From: Helen Webster
Sent: 17 November 2015 12:17
To: Planning
Subject: FW: NYM/2015/0675/FL - Victoria Hotel
Attachments: 15.062.03 B - PROPOSED ELEVATIONS.pdf; Entrance Sketch - Castellated detailing.pdf; Sketch 1.pdf

From: Emma
Sent: 17 November 2015 12:12
To: Helen Webster
Subject: NYM/2015/0675/FL - Victoria Hotel

PROPOSED ORANGERY TO VICTORIA HOTEL, ROBIN HOODS BAY
 ELEVATIONS AS PROPOSED

DRAWING No. 15/062/03B

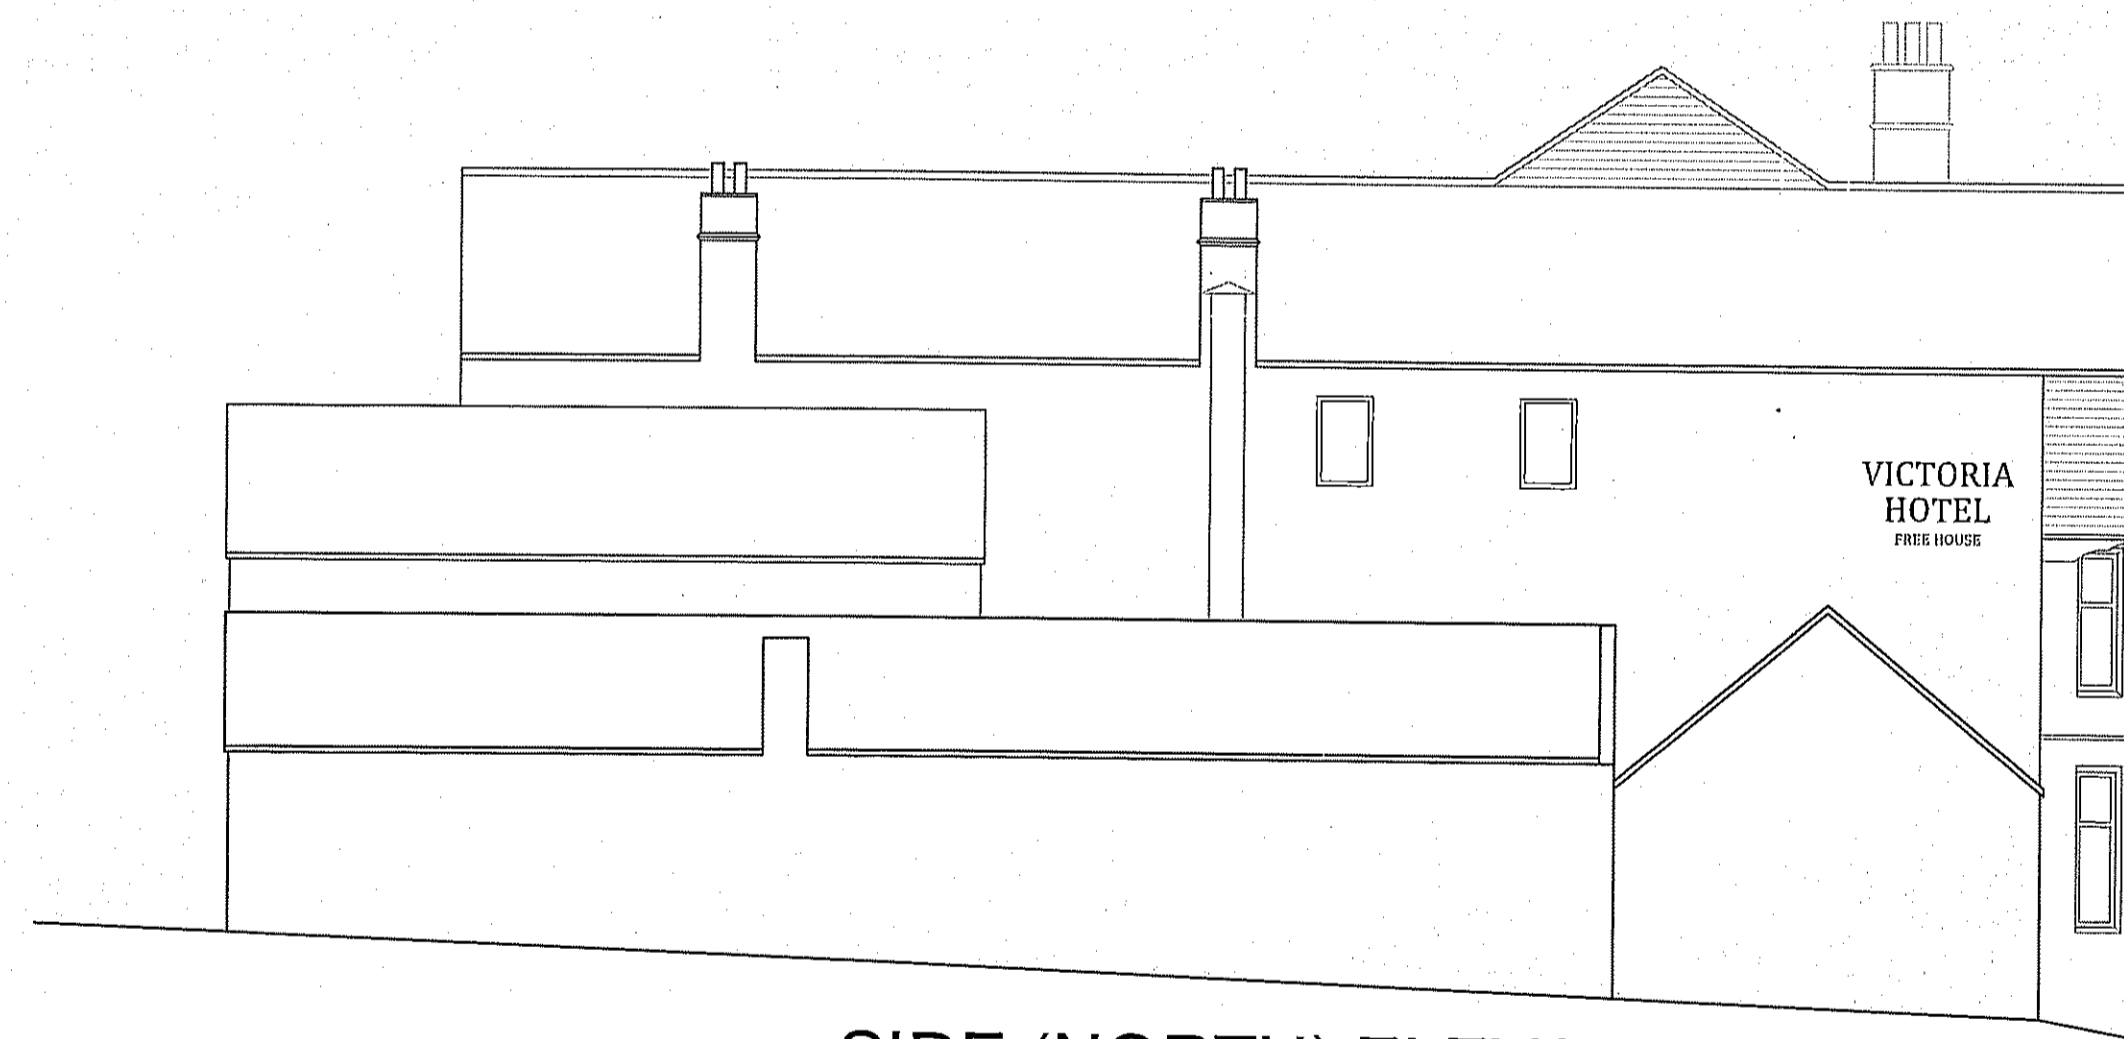
In order to emulate the existing features, we have amended the pitched parapet over the central doors to include vertical timber detailing similar to that in the lean to gables. Glazing bars have also been shown in the upper orangery windows as requested.
